INVITATION TO TENDER "ITT" No. PS20180883 RODDAN LODGE CONSTRUCTION

QUESTIONS AND ANSWERS No. 9

ISSUED ON JULY 25, 2018

<u>i</u>	Layout of room 121

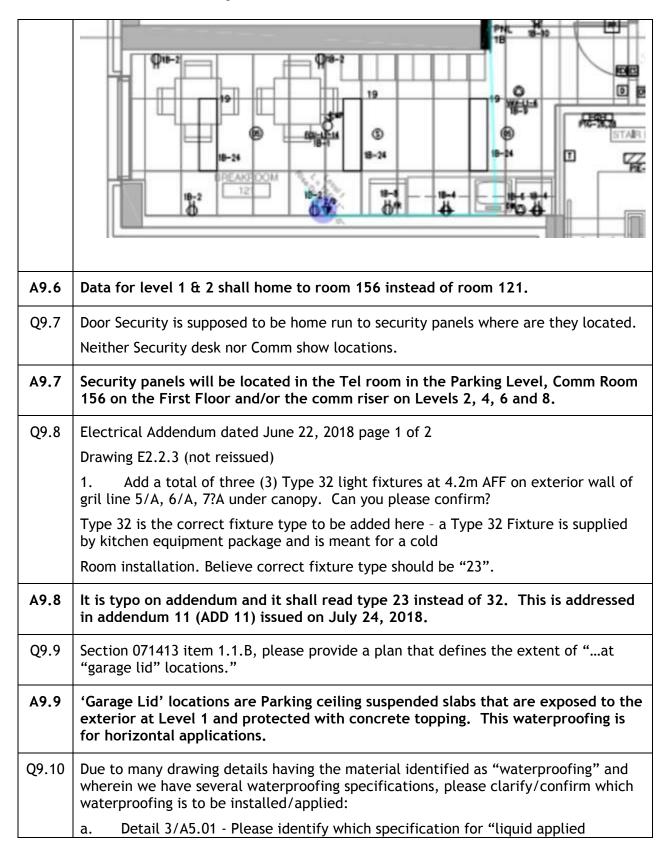
Q9.5	From Electrical contractor:
	-Division 28. Would the owners provide their Milestone SLC Number to identify all existing licenses?
	-Division 28. What is the software version of the Keyscan Server?
	-Division 28. Does the Keyscan Server have any existing integration licenses for DSC, EnterPhone and Milestone?
A9.5	-Division 28. Would the owners provide their Milestone SLC Number to identify all existing licenses?
	Security consultant advised Contractor to provide all Milestone licenses required for new cameras and workstations.
	-Division 28. What is the software version of the Keyscan Server?
	Aurora Version 1.0.17.0.
	-Division 28. Does the Keyscan Server have any existing integration licenses for DSC, EnterPhone and Milestone?
	Not required.
Q9.6	Data for Level 1 and 2 is supposed to go to room 121 a breakroom, not 156 the Comm. Room! Please confirm
	PLANS LOGGE OFFICE AND LIBRARY 1°C W/CAT6 2-3°C FOR TELEPHONE HOTE-B 2-3°C FOR SHAW AND RADIO ANTENNA E-COMM SYSTEM, CATY CABLE BY SHAW 1°C W/CAT6 COMM DROP AT LEVEL 1 COMMUNITY DATA CLOSET IN ROOM 121 DATA RACK PLANS OUANTITY SHALL REFER FLOOR PLANS
